# 中國工控
IPC CHINA

1U solution for Intel LGA1150 LGA1155 LGA1156 Xeon 1230 CPU Socket clip
April 12, 2019

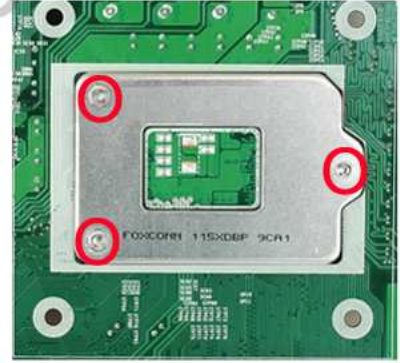
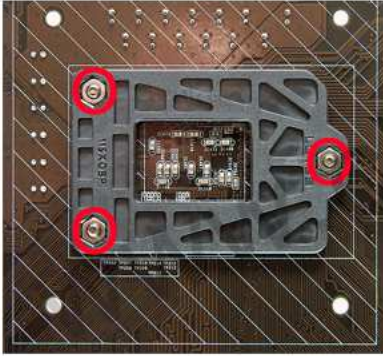
Solution 1: Shorten the 3 screws at back side of motherboard, see above RED circles
Solution 2: or Drill 3 holes at bottom of 1U chassis in order to accommodate the longer screws
Solution 3: If neither the 1st nor the 2nd solution, please order some #6 x 6mm high screws and
    some 5mm high plastic stand-off, see the photo below.

#6 screw is 6mm high

Our standard metal stand-off height is 2.8mm~3.0mm

Plastic stand-off is 5mm high
